*Re: Application of Dino and Michelle DeLaurentiis for Site Plan Approval for the
Construction of a Single-Family Residence and a Tree Removal Permit
To Permit Tree Removal in Connection with the Development of the Residence
Property: 21 Nethermont Ave. North Castle Tax Map Section 122.16, Block 4, Lot 41*

MEMORANDUM

SUBJECT: 21 Nethermont Ave

DATE: June 21, 2022

UTILITY PLAN

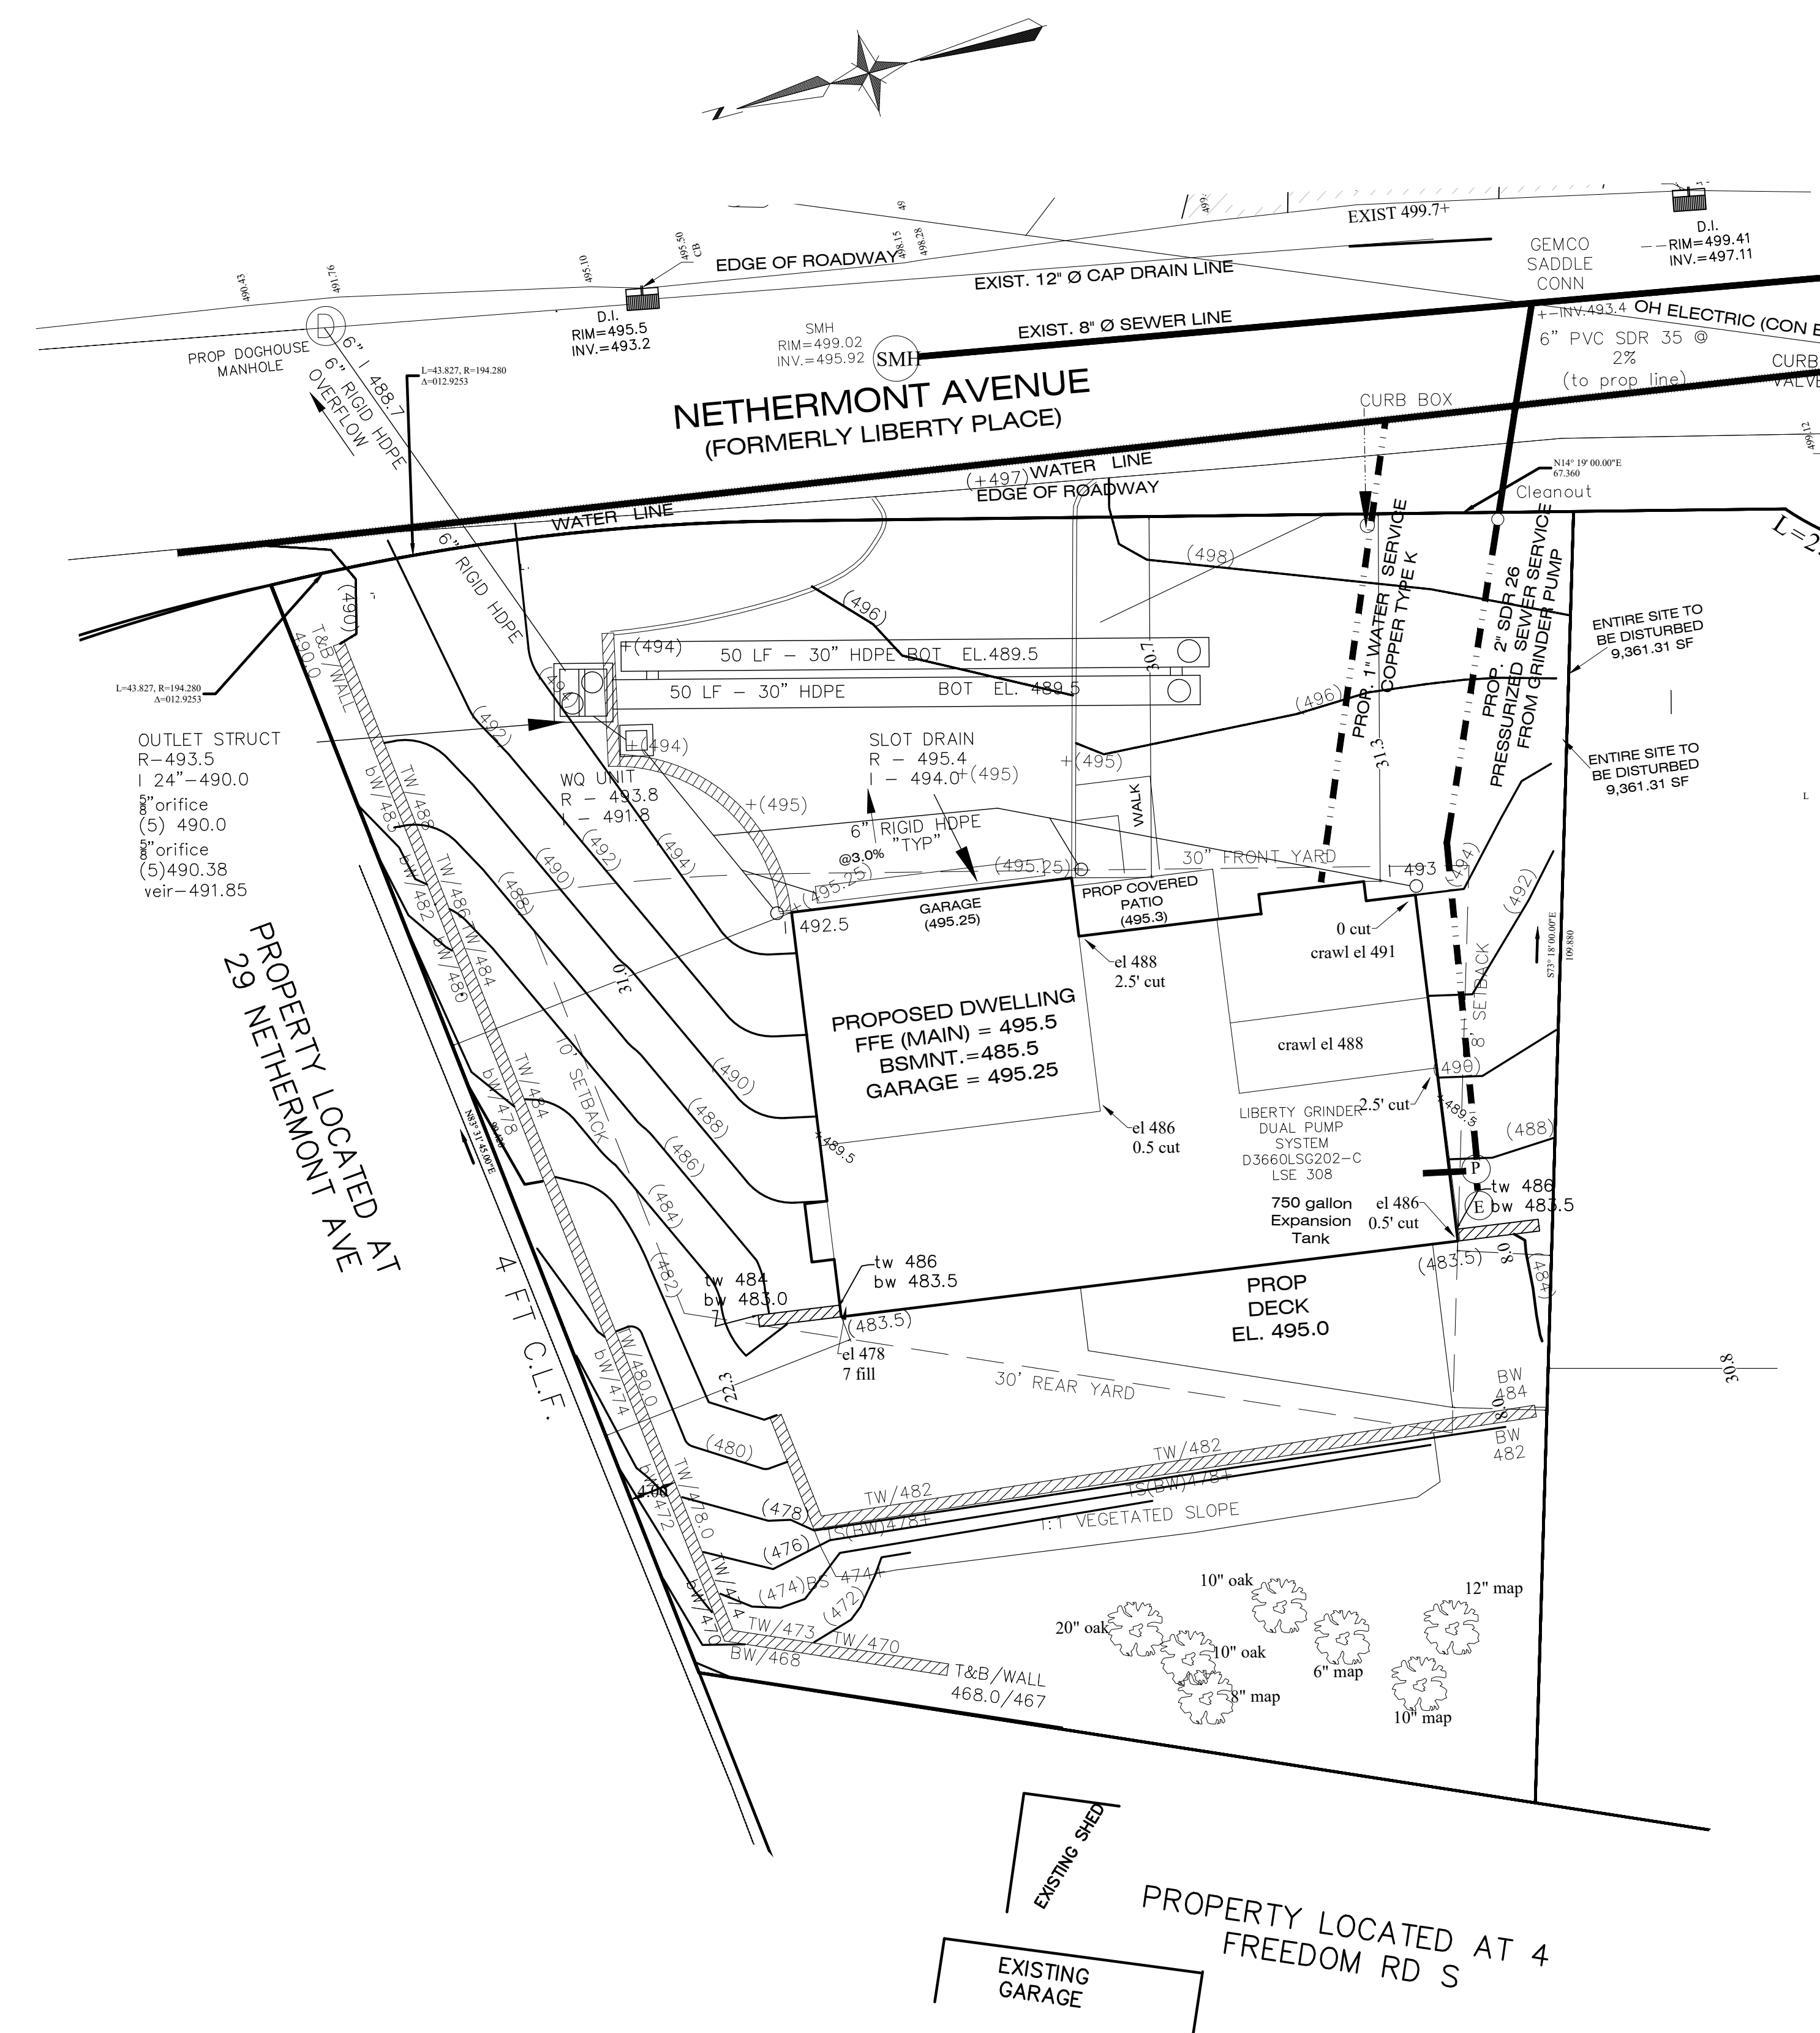
The sewer force main has been shown as a direct connection into the gravity sewer within Nethermont Avenue. I believe the Town Water and Sewer Department will require the force main to discharge into a new manhole on the applicant's property and flow by gravity to the main sewer from the manhole. Please meet with the Water and Sewer Department to clarify the connection details. Also, the headers on the utility profile for water and the sewer main appear to be interchanged. Please correct profile.

14. As previously requested, illustrate the connection between the storm system in the driveway and the existing storm system in Nethermont Avenue. Provide invert elevations as appropriate.

It appears that the requested rim manhole on the and invert elevations have been provided. We note, however, that the plan proposes to connect the discharge to the mitigation system directly to the pipe, as opposed to a manhole structure. The applicant may need to install a doghouse existing storm line. The details of this construction can be reviewed with the Highway Department as the plan develops. We will defer detailed review of the Stormwater Report until an alternative has been selected for development. We note that the stormwater calculations provided on the plan sheets are illegible and should be removed. In addition, the hydrologic model proposes a single design point. Under existing conditions, the design point is at the base of the hill at the rear of the property where

At the request of the Water and Sewer Department the 2” force main is to be connected to a 6” gravity connection at the property line. The 6” gravity wye connection will be connected to the sewer main with a Genco saddle connection. Connection detail shown and “headers” have been revised on Utility Profile. See SW-4

The connection to the storm drain is now made with a doghouse manhole. Drainage report shows design discharges. Location and invert of connection shown on SW-2. Details for doghouse manhole connection are shown on SW-4.

CROSS SECTIONS

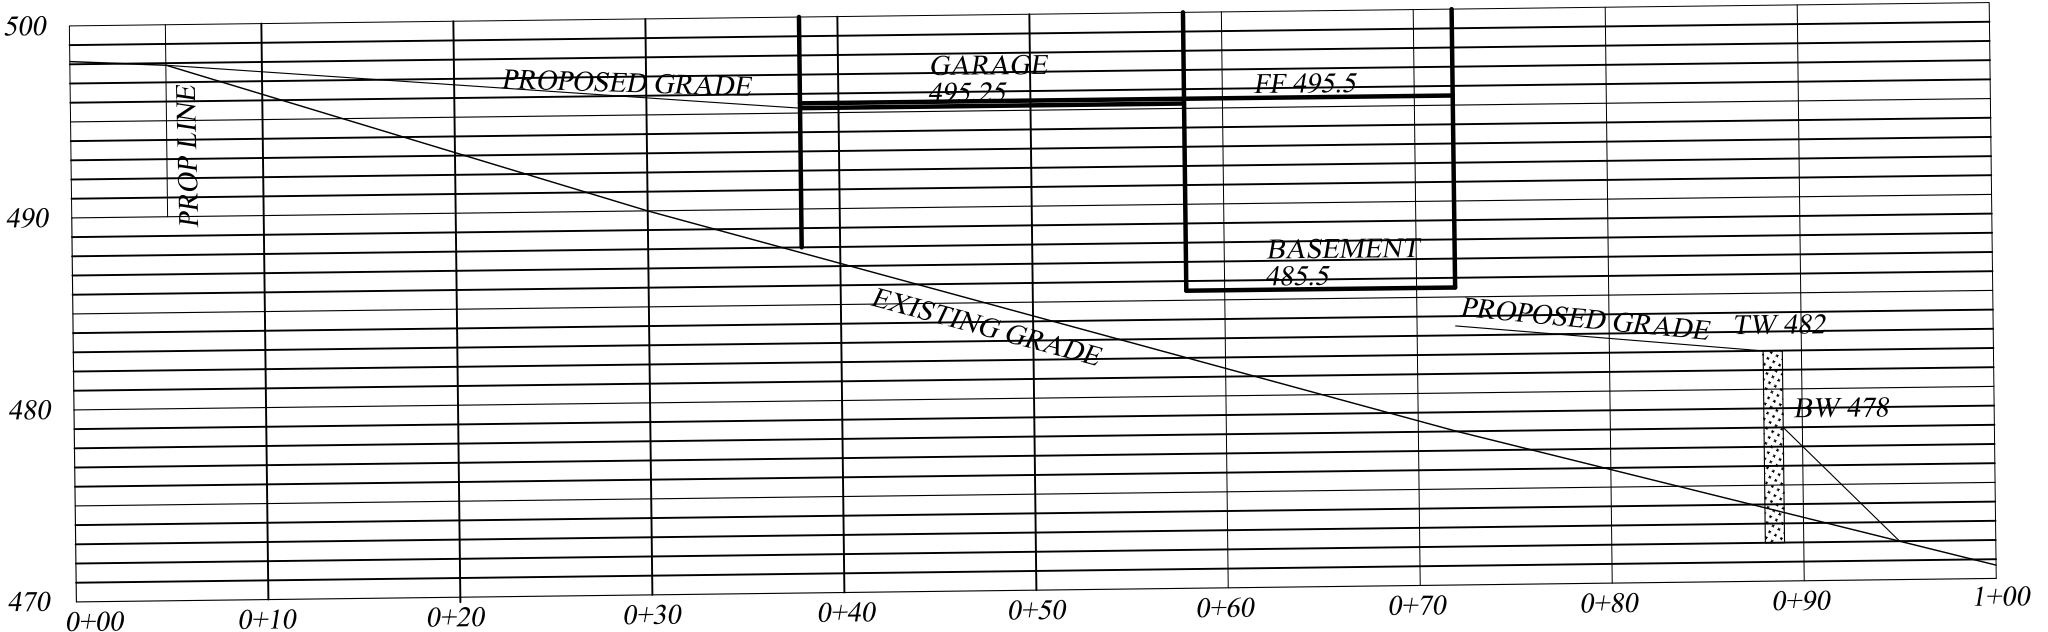
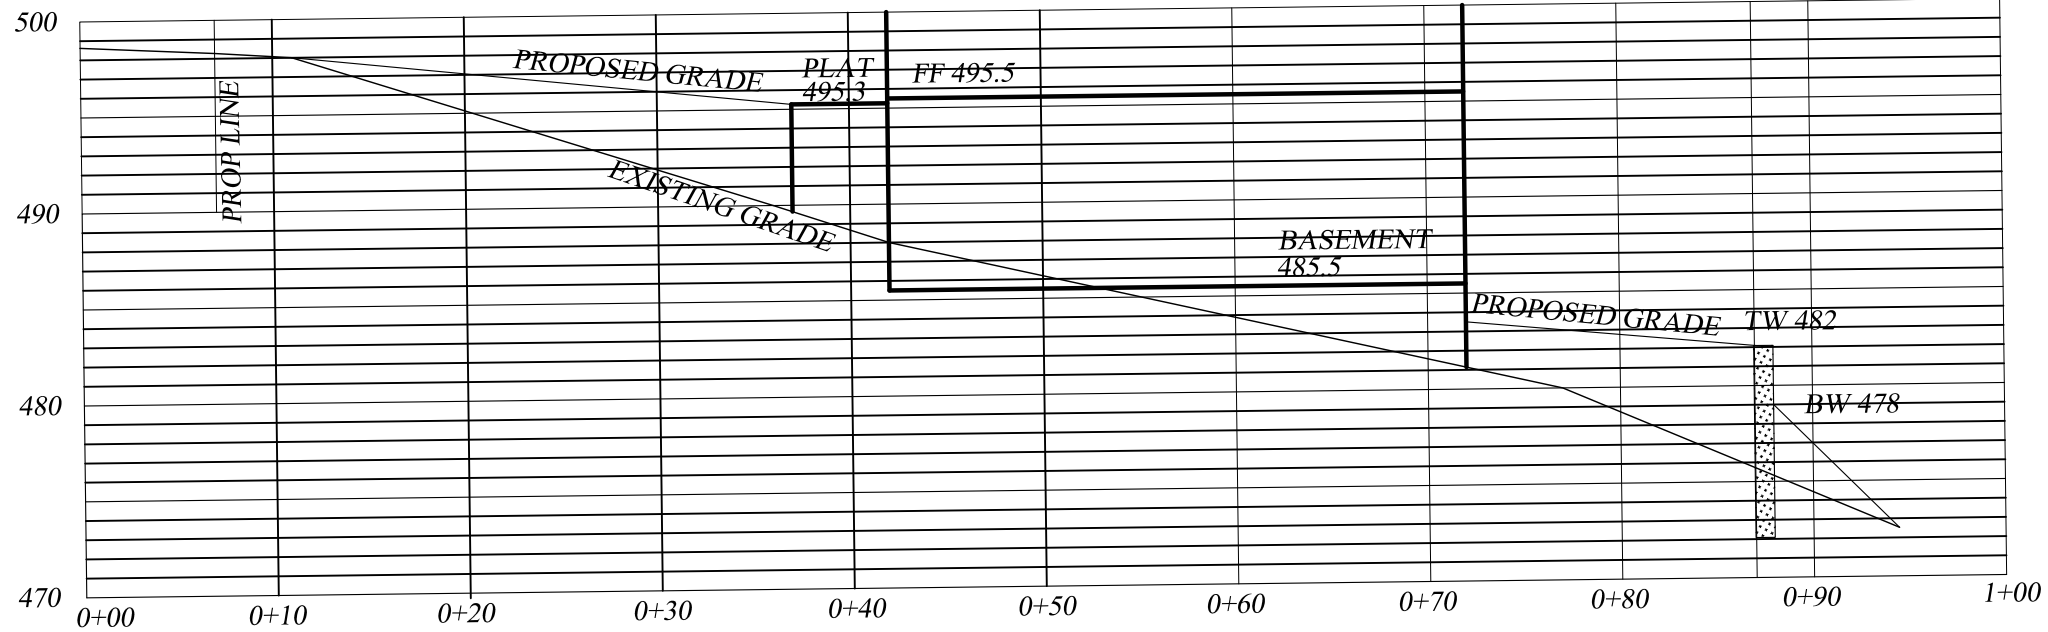
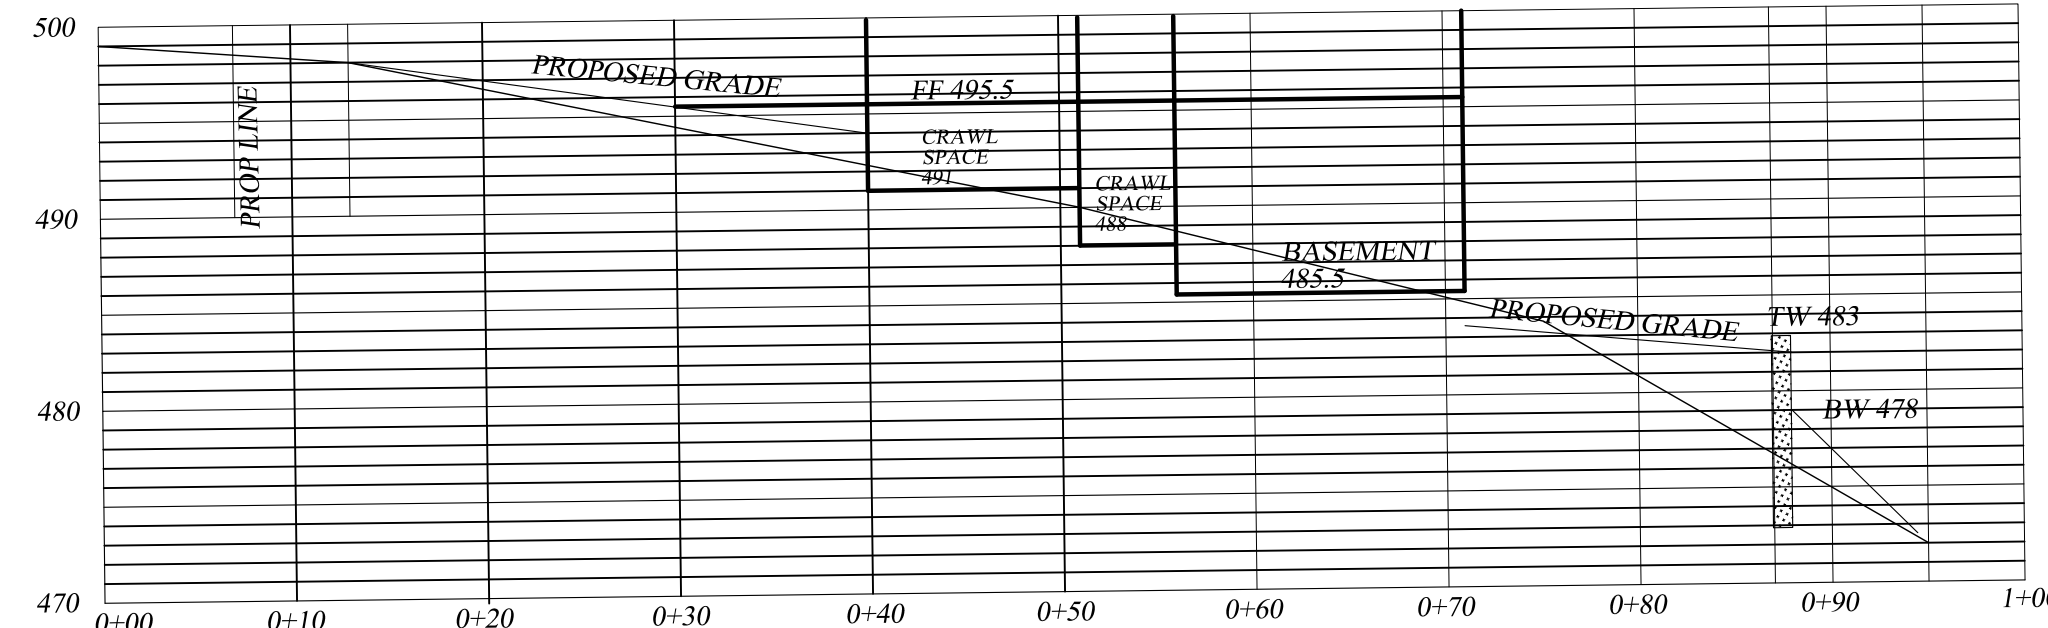
3. As previously noted, the plan proposes tiered six (6) foot high retaining walls in the rear of the property, in close proximity to the property line. The Board should review the retaining wall layout and consider whether they are aesthetically pleasing and compatible with the surrounding residential character. Additional screening or other mitigation may be recommended. The Board may wish to consider reducing the height of the tiered walls or adding a third tier (three — 4-foot walls as opposed to two — 6 foot walls). The applicant should provide cross sections at appropriate locations through the site, front to back and left to right, for the Board's understanding of how the proposed grading and retaining walls will relate to adjacent properties.

While minor modifications to the retaining wall layout have been proposed, it is our opinion that additional modifications can be made to further reduce the retaining walls along the property lines as well as to improve the proposed grading adjacent to the residence. As currently proposed, the finished grade immediately falls from the foundation providing no level side yard and poor access to the proposed stairs at the northwest corner. The applicant may wish to consider shifting the wall along the side yard toward the home or adding a short second tier to flatten the proposed grades around the house. It also seems that the wall at the rear property line could be shifted further into the site to minimize visual impact to the adjoining property. The requested cross sections have not yet been provided.

At the May 23rd meeting of your Board on this Application the applicant was advised to consult with Town Engineer John Kellard about alternatives to the wall design proposed on the Site Plan/Zoning Analysis/Grading Plan (SW-1), prepared by Gabriel E. Senor PC, dated October 3, 2021, last revised May 5, 2022. The applicant has consulted with Mr. Kellard about that aspect of the plan and based on that consultation, we have replaced the originally proposed rip-rap slope with a 1:1 vegetated slope to preserve 6 Town Regulated existing trees and one tree with a DBH of 6 inches in the rear of the property.
